Change Application (Minor Change) Town Planning Assessment

15-17 Mollison Street, South Brisbane and 35-
39 Bank Street, West End

MEWIN G
PLANNING
CONSULTANTS

Figure 1: Comparison of approved and revised basement level setback towards Mollison Street

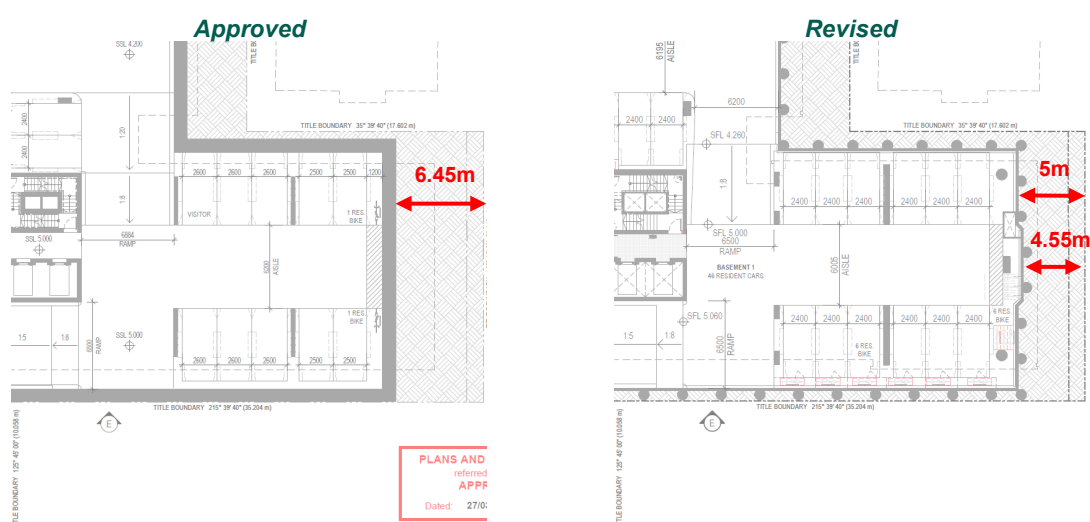
- The basement setback towards Mollinson Street has been reduced from 6.45m to 5.00m (4.55m for a small portion to accommodate a terminated aisle for reversing manoeuvres) to allow for the basement levels to be reconfigured to accommodate additional car parking spaces in response to proposed changes to development yield and bedroom composition, and also to facilitate a more efficient and functional construction program.

To minimise impacts on adjacent deep planting areas, the basement construction has been revised from a solid wall to pier and pile design and has increased basement setback in other parts. This change results in a minor reduction in the extent of deep planting by approximately 63.4m², however deep planting continues to be provided to the Bank and Mollison Street frontages and to the north-western neighbour, with a consistent number of large subtropical shade trees provided (albeit shifted around slightly). Nevertheless, the proposed development continues to comply with **PO28 / PO29** of the Multiple Dwelling Code, with 12% (2450.5m²) of the total site area proposed as deep planting and landscaping (comprising 9% compliant deep planting (clear above and below) and an additional 3% deep planting clear below (with a height clearance of 8.5m to accommodate large subtropical shade trees)).

Figure 2: Proposed relocation of resident bicycle parking spaces.

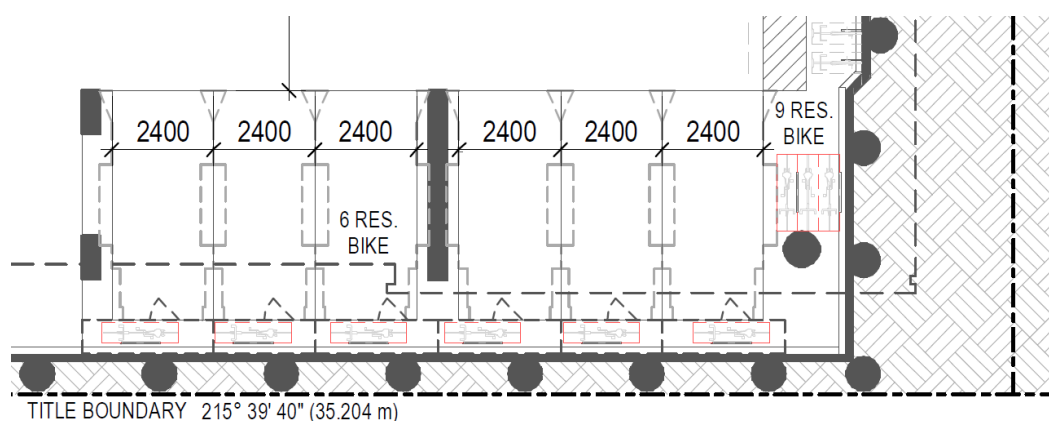
- Furthermore, the proposed development seeks to relocate a portion of the residential bicycle storage areas within the basements to accommodate the additional car parking spaces. This change includes the introduction of storage cages directly adjacent (and not extending within) the car parking spaces, collocated with assigned car parking spaces for convenience on use by residents. **Figure 2** indicates the proposed location of resident bicycle parking spaces.

Figure 3: Revised non-residential tenancy and ground floor plane

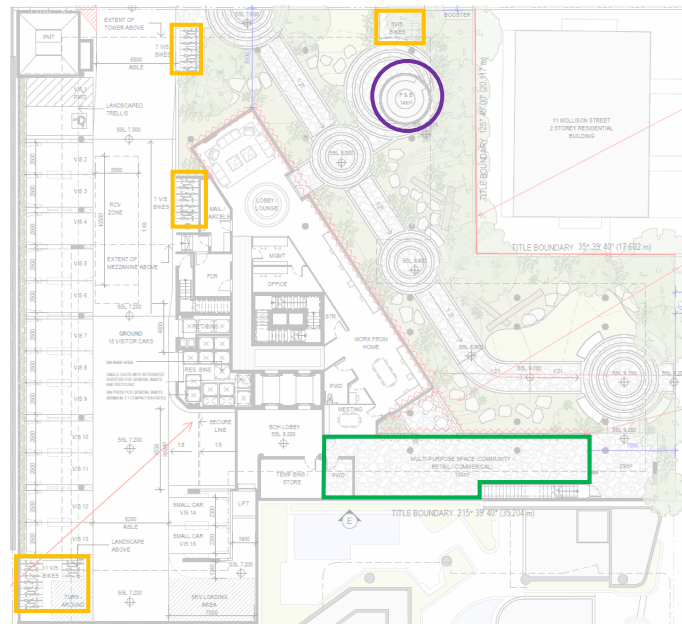
- The proposed non-residential tenancy (multipurpose space for community / retail / commercial) located adjacent to the southern boundary has been reconfigured in conjunction with the publicly accessible space changes (change depicted in **green** within **Figure 4** below).

The external façade of the tenancy has been designed to run parallel with the pedestrian link, with an increased front setback of 11.67m (7.00m approved) widening the view corridor through the site (between Mollison Street and Bank Street). The internal floor area has reduced slightly from 100m² to 96m², however the adjacent outdoor terrace has increased in size by 30m². This changes greatly improves the functionality and amenity of the space by seamlessly blending indoor and outdoor areas, through its revised configuration and proximity to the pedestrian spine and adjacent landscaped areas (including revised landscape pavilion) and an improved terrace interaction with Mollison Street and extra interface with the internal public space. Refer to **Figure 4** below.

Figure 4: Comparison of Approved and Revised Ground Level
Source: Rothelowman, 2026

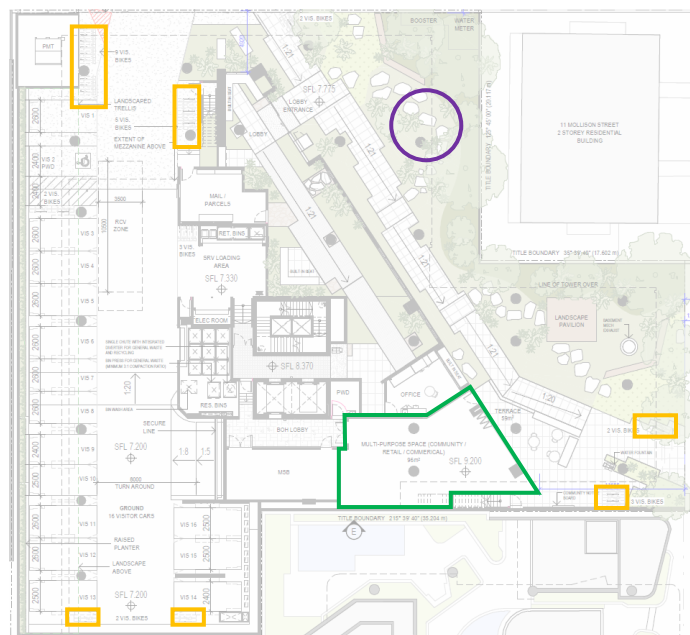
- As demonstrated within the Architectural Plans prepared by Rothelowman, the food and drink outlet within the landscaped publicly accessible private open space (PAPOS) and directly adjacent the dwelling house at 11 Mollison Street has been removed (change depicted in **purple** within **Figure 4** below). The proposed change is intended to provide an improved amenity interface with the neighbouring dwelling house, and increase the public realm outcome and landscaping on ground level.

- Minor and inconsequential reconfiguring of the publicly accessible private open space (PAPOS), resulting in an additional 2.7m² of PAPOS. The revised ground level improves the direct line of site from the entry off Mollison Street through to Bank Street. Entering earlier at the point at which Mollison Street changes direction creates a more fluid and organic movement path into the site. Refer to **Figure 4** below.

- The design of the entrance into the residential lobby has been revised, with the overall size of the internal lobby reduced (giving back to landscape and public space) including reconfiguration of the on-site manager's office and mail / parcels room. It now includes a more defined entrance that includes open air / landscaping that is separate from the main pedestrian spine and providing additional communal recreation space available for residents.

- An additional visitor car parking space (16 spaces now proposed) has been provided within the car parking / internal driveway on ground level, and in response to the proposed increase to yield and changes to bedroom composition. The approved small car parking spaces for visitors (spaces 14 & 15) have been replaced by full-width spaces (2.5m wide).

- Visitor bicycle parking spaces have been relocated across the ground level, as a consequence of incorporating the additional visitor car parking space. The revised bicycle parking spaces are depicted in **orange** outline within **Figure 4** below, and continuing to be located in areas that are publicly accessible and will be clearly signposted.

- Repositioning of SRV Loading Area from the southern corner of the site to adjacent the mail room as a consequence of the additional visitor car parking space proposed. Please refer to the Traffic Letter prepared by Lambert & Rehbein and included in **Attachment E** for further detail.

Figure 5: Comparison of approved and revised mezzanine level.

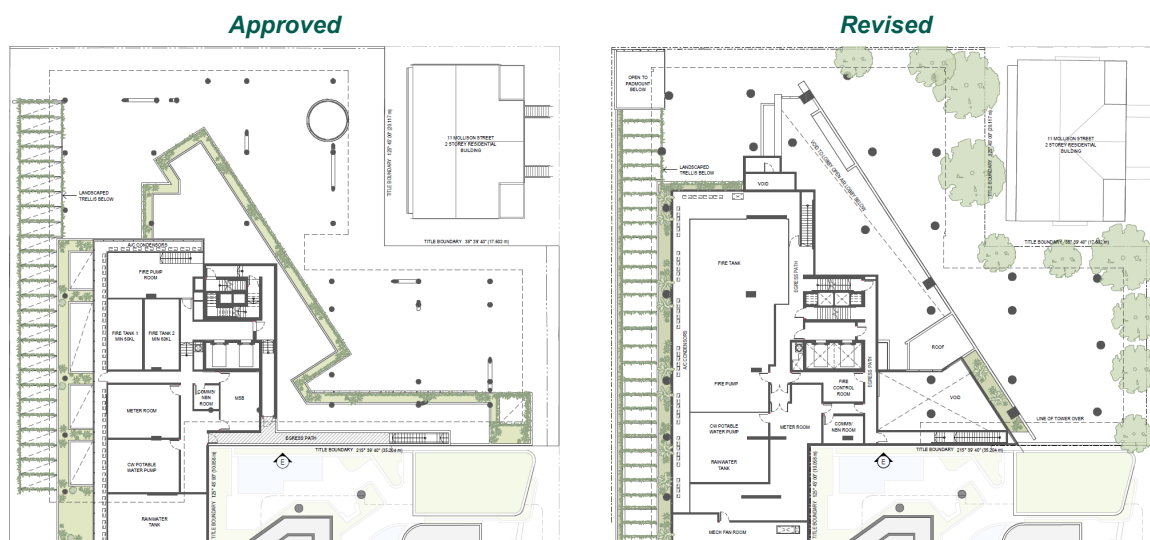
- The extent of the landscaped trellis that spans over the top of the car parking area on ground level has been extended along the entirely length of the south-western side boundary. Refer to **Figure 5** below.
- As discussed in **Section 3.1.3**, the proposed changes to the configuration of the residential lobby entrance and multiple purpose space on ground level has resulted in a redesign to the void space associated landscape planters on the mezzanine level (as illustrated **Figure 5** below). This change has allowed for additional landscaping to be provided for on ground level (beneath the void), which integrates with the PAPOS.

Figure 6: Typical Floor Plate Comparison (levels 3-11)

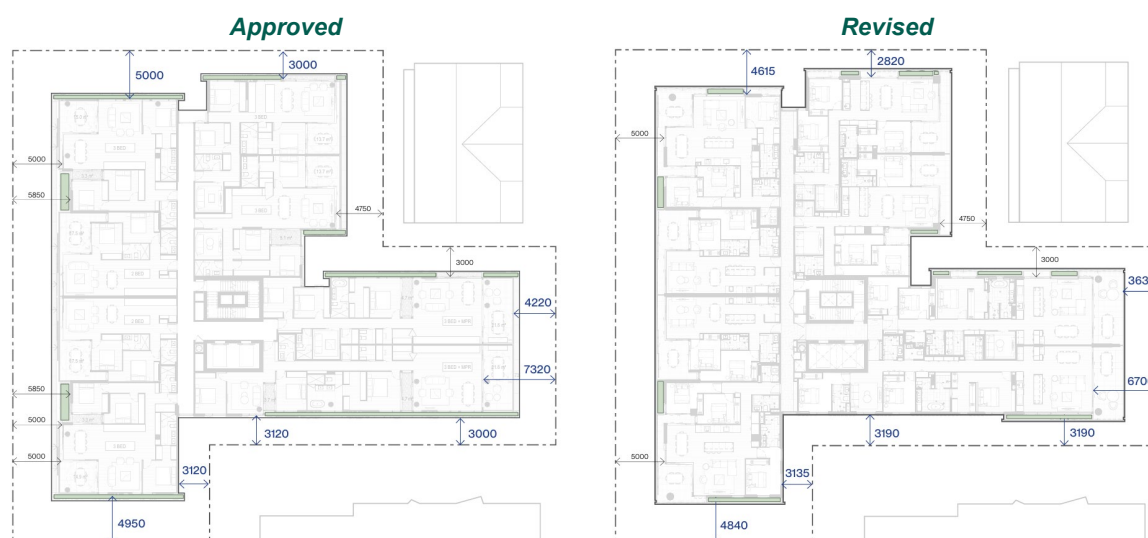
Setbacks for the proposed tower has been amended in part as a consequence of detailed design but importantly the overarching shape of the being and revised setbacks being commensurate with the approved outcome (as illustrated in the Architectural Plans contained in **Attachment C**).

On average, setbacks to main building line have been maintained towards the common property boundaries, however there are some minor reductions for architectural design elements such as Juliette balconies and slab projections / landscape planters. Setbacks to Bank Street have altered by between 0.2 to 0.4m, whereas the setback to wall for Mollison Street (set behind the front facing balconies) have reduced from 7.3m to 6.7m (0.6m change), whilst maintaining consistency with the alignment of the adjacent tower.

Figure 7: Comparison of Approved and Proposed Floorplate for Level 2

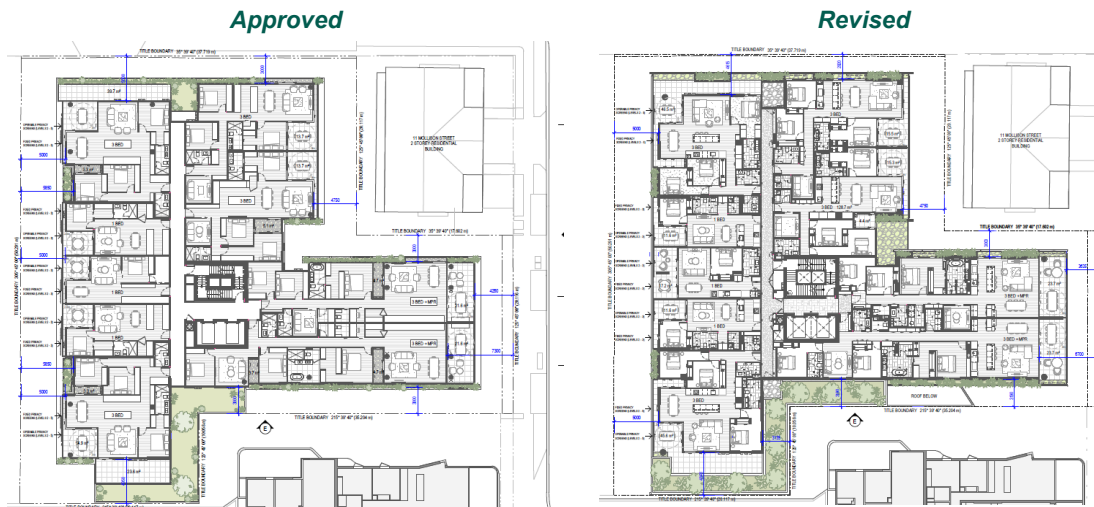
The podium planter along the south-east boundary of the site has been increased in its length and the private open space for the adjacent unit consolidated into a single area (45.6m²) to improve functionality and amenity outcomes (as illustrated in **Figure 7**).

Other changes including removal of the slab projections towards Mollison Street and infilling the central recess with additional landscaping.

Figure 8: Comparison of Approved and Proposed Floorplate for Levels 3-10

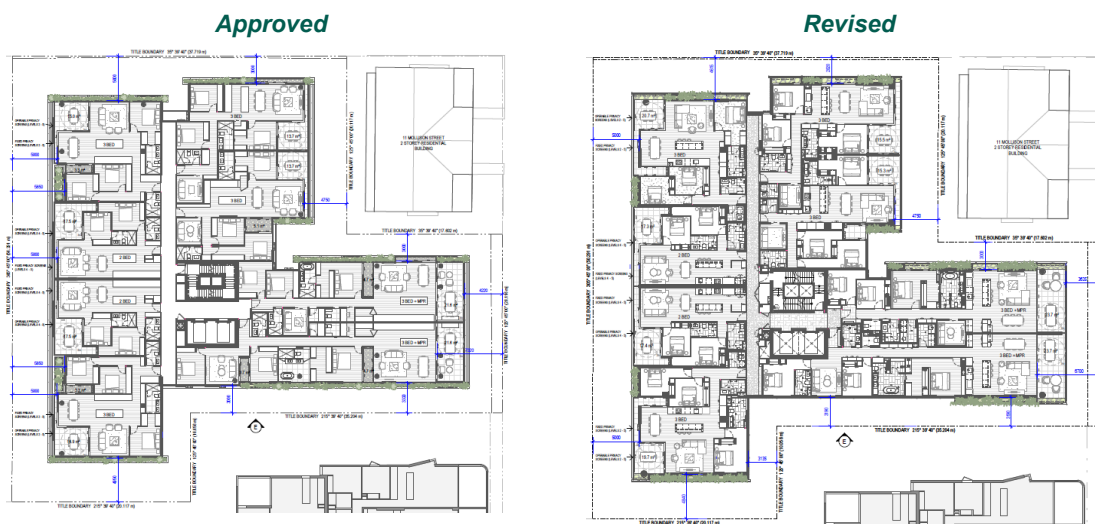
There has been a rationalisation in the number and extent of slab projections and landscaping planters incorporated along the building facades. Importantly, recesses incorporated along the façades have been maintained (widths and depths generally consistent with the approved development) and along with the balconies and landscape planters to the exterior ensures appropriate articulation and movement to the building's facades to lessen the appearance of bulk and scale towards the street and adjoining properties.

Figure 9: Comparison of Approved and Revised Level 11

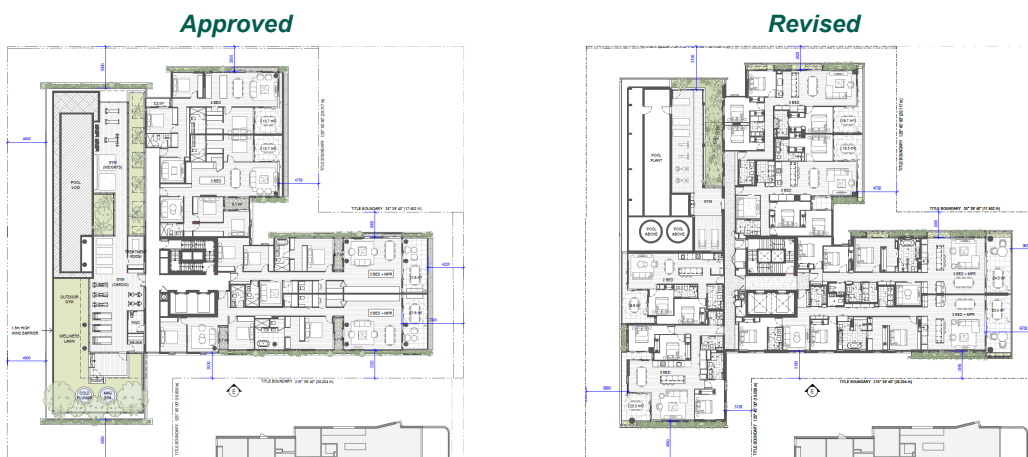
Two (2) additional units comprising one (1) x 2 bedroom unit and one (1) x 3 bedroom unit is proposed within the south-east corner of the building, replacing the outdoor gym and wellness lawn. As a consequence of this change, there has been a reduction on the extent of communal open space on level 11 but has been otherwise been relocated to level 12 above and or the rooftop terrace (level 19).

Figure 10: Comparison of Approved and Revised Level 12

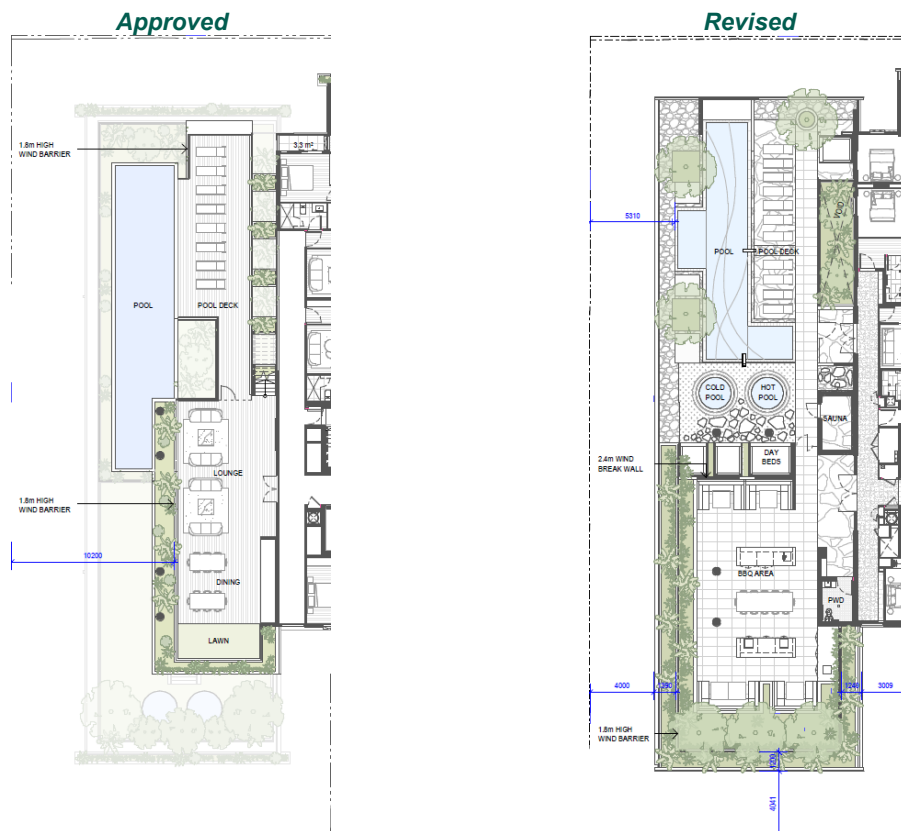
In response to the incorporation of an additional two (2) units on level 11, expanded communal open space has been incorporated on level 12 (as illustrated in **Figure 10**). This communal open space area runs the entire length of the building's south-west façade (open to the sky with lightweight pergola structure) and comprises generous landscaping, day beds, outdoor dining areas, BBQ area, cold and hot pools, and pool deck. The revised outcome notably provides an improved landscape outcome to the eastern and southern side facades and neighbouring developments.

Figure 11: Comparison of Approved and Revised Level 15

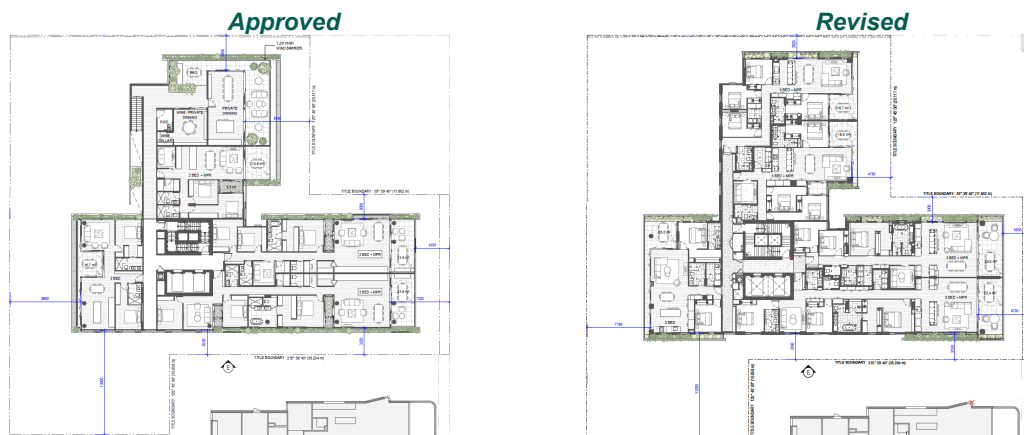
The private dining rooms, wine cellar and associated outdoor BBQ area on level 15 has been removed and instead relocated to the communal recreation areas on levels 11-12 or the roof terrace (on level 19). Consequently, the external stairs that previously provided access between the communal open space on levels 11 and 15 has been removed and increased the building setback towards the side boundary. The floor plate on level 15 has been reconfigured as part of this change and contributes to the overall increase in development yield.

Figure 12: Roof Terrace

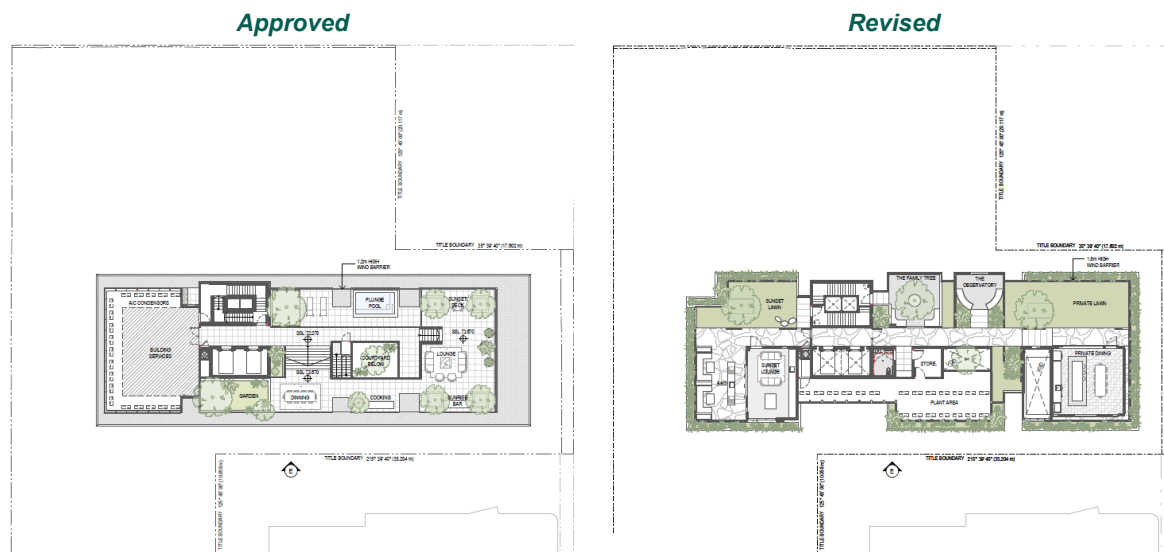
Level 19 is now proposed for residential purposes (constituting a new storey), with the approved communal open space and building service now incorporated on a level 20 (as illustrated in **Figure 12**). The new rooftop terrace has been designed in full compliance with the City Plan administrative definition for 'rooftop garden' and therefore does not constitute a separate storey.

As such, the proposed development has a maximum building height of 19 storeys, which is one storey greater than the approved development.

Figure 13: Proposed building façade treatments

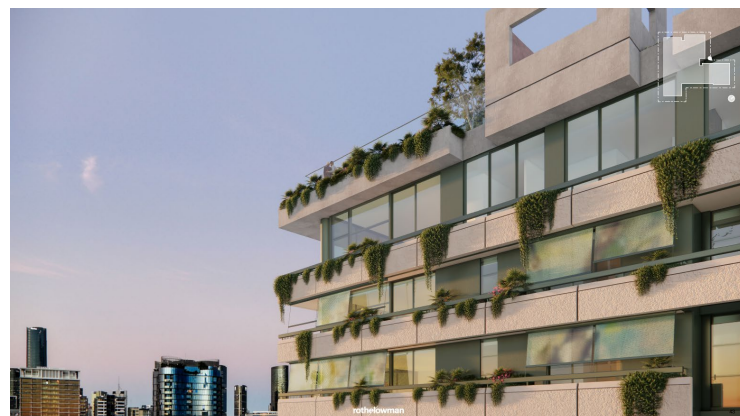
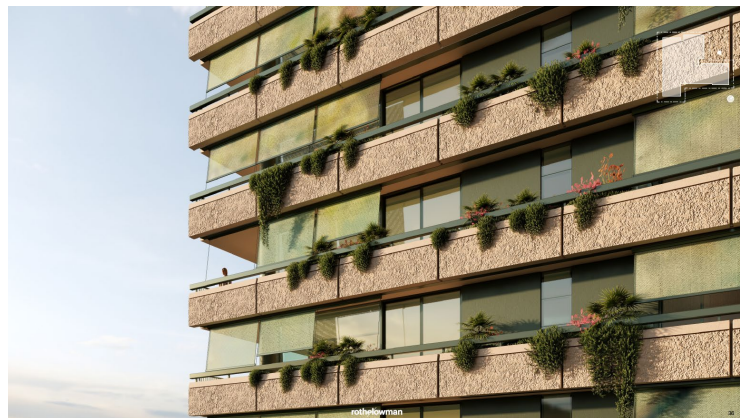
- Precast concrete upstand in lieu of downturn to provide shade, privacy and high-quality finishes;
- Refinement of operatable screens, planters and Juliette balconies;
- A silhouette of landscaped follies and pavilions provide variety and interest on the skyline;
- Vertical precast expresses have been created where solid façades are appropriate.

Figure 16: Mollison Street Elevation

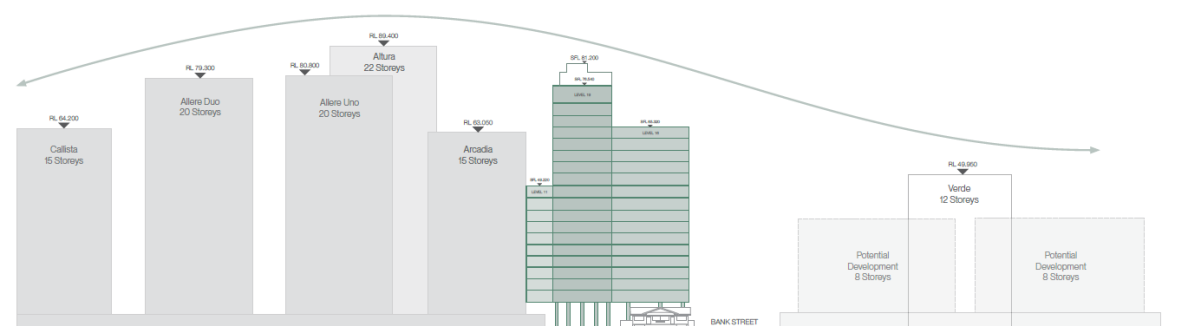
- The development is proposed to increase by only one (1) storey, which in the context of an approved 19 storey (inclusive of rooftop), presents a similar scale to the street and adjoining properties.
- The proposed development maintains the distinctive built form, with variations in height and rooftop caps. The built form continues to facilitate a transition in height from taller residential development associated with the West Village and stepping to development opposite Bank Street. Refer to **Figure 16** below.
